Access Compliance Report Public Rights-of-Way (Curb Ramps)

Main Street: VINE_ST Cross Street: RANCHO_SANTIAGO_BLVD Location: NW

ADA ID: RPAT210928091930 Ramp Type: Type 4 - Parallel Initial Pass/Fail: Fail Overall Compliance: No Severity Score: 16

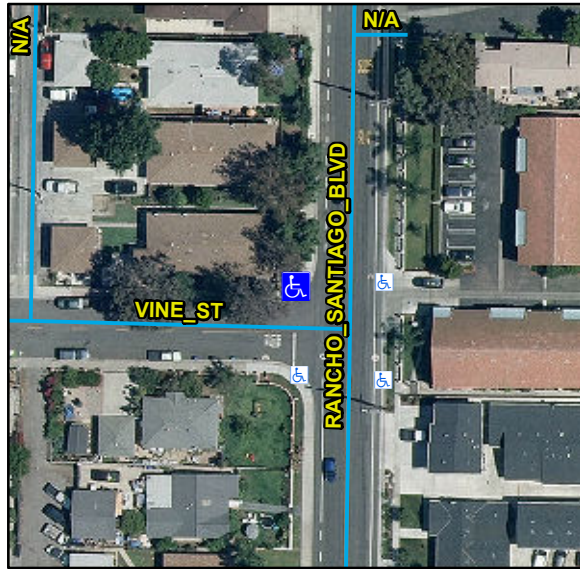
Compliance	Description	Data	Compliance	Description	Data
N/A	Ramp Length LT (in)	99	N/A	Ramp Length RT (in)	103
Yes	Ramp Width LT (in)	54	Yes	Ramp Width RT (in)	54
Yes	Ramp Run Slope LT (%)	1.7	No	Ramp Run Slope RT (%)	10.2
Yes	Ramp Cross Slope LT (%)	1.4	No	Ramp Cross Slope RT (%)	2.4
N/A	Landing Present	N/A	N/A	DWS Provided	N/A
N/A	Landing Length (in)	N/A	N/A	DWS Contrast	N/A
N/A	Landing Width (in)	N/A	N/A	DWS Length (in)	N/A
N/A	Landing Run Slope (%)	N/A	N/A	DWS Full Width	N/A
N/A	Landing Cross Slope (%)	N/A		DWS Offset Type	N/A
N/A	Landing Movement Obstructed?	N/A	N/A	DWS Offset Left (in)	N/A
	Landing Movement Type	N/A	N/A	DWS Offset Right (in)	N/A
N/A	Landing Shared	N/A			
N/A	Clear Space	Yes			
N/A	Clear Space To Crosswalk (in)	N/A			
N/A	Marked Crosswalk 1	No	N/A	Marked Crosswalk 2	No
	Crossing 1 Direction	S		Crossing 2 Direction	E
	Marked Crosswalk 1 Width (in)	N/A		Marked Crosswalk 2 Width (in)	N/A

Remove & Replace Curb Ramp With Two New Directional Ramps or Equivalent.
